Final Drainage Report

**Jackson Ranch
Filing No. 3**

Project No. 61044

Add: "PCD Project No. SF-17-017"

Existing Drainage Map
Developed Drainage Map

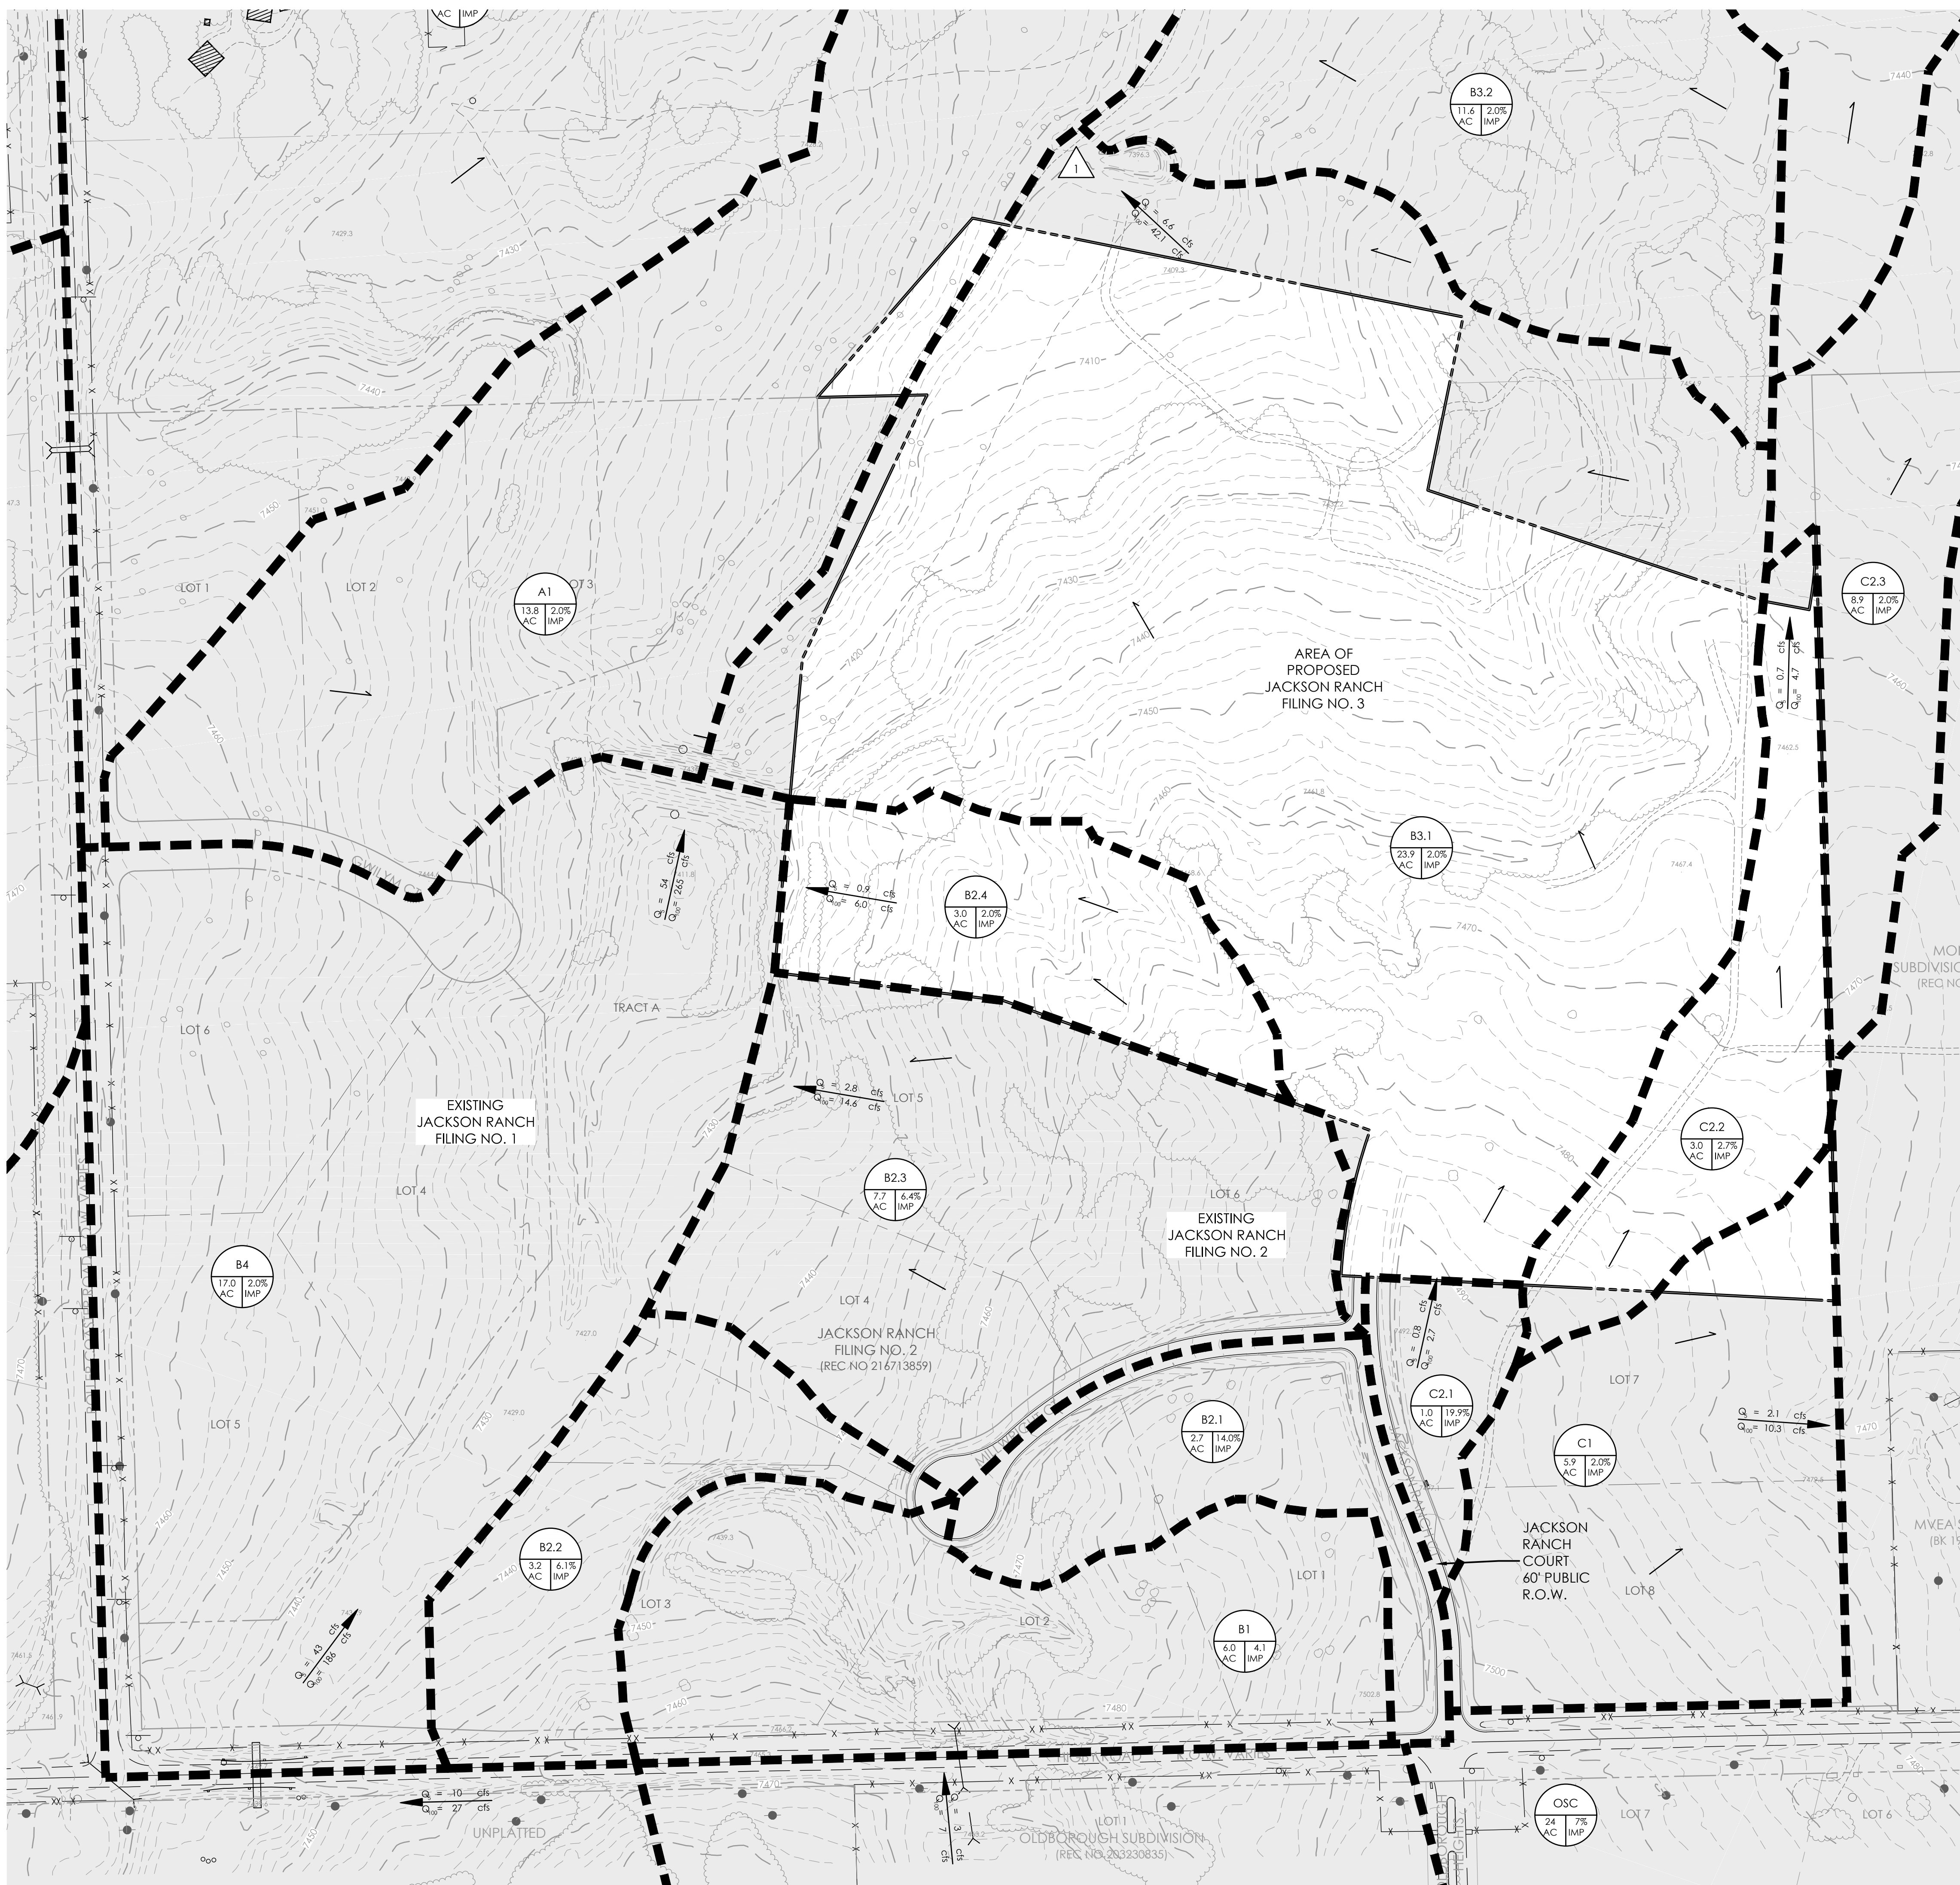
Provide calculation for the ditches. See Table 10-4 of the DCM for permissible velocity. If the seed is similar to grass-legume mixture then permissible velocity is 4 fps for channel slope between 0-5% and 3fps for 5-10% slope.

EXISTING
DRAINAGE MAP

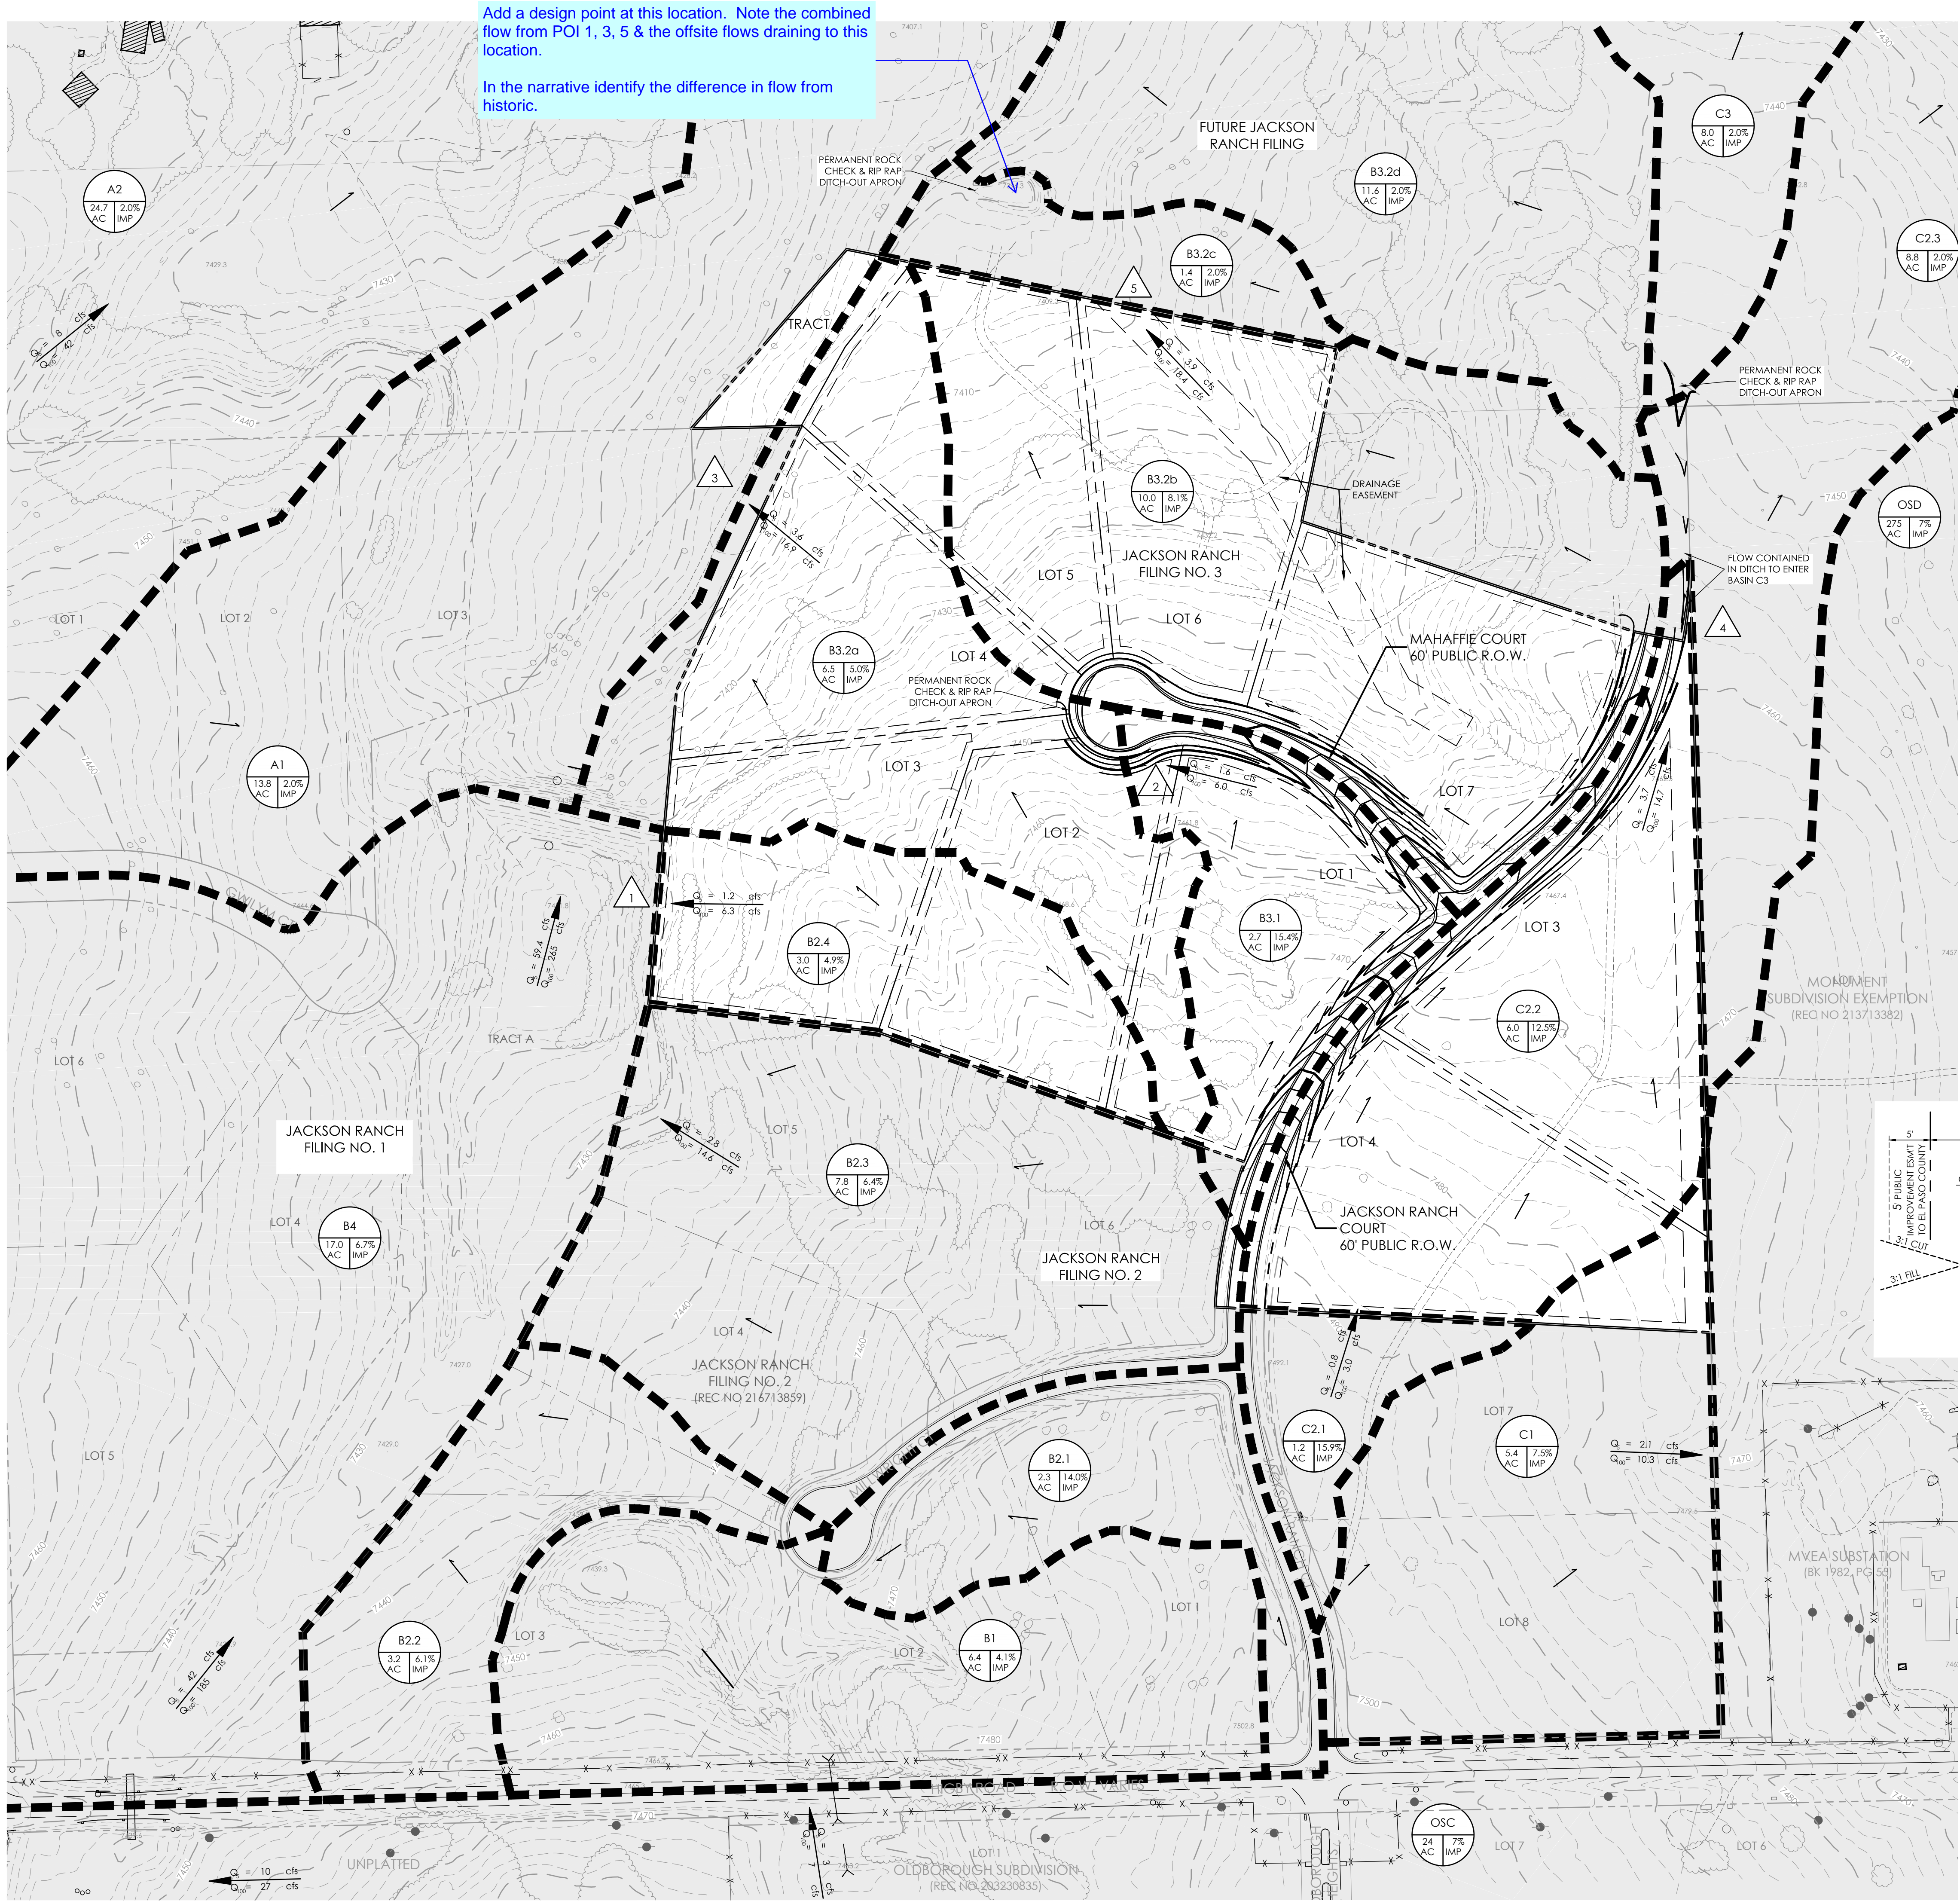
Add a design point at this location. Note the combined flow from POI 1, 3, 5 & the offsite flows draining to this location.
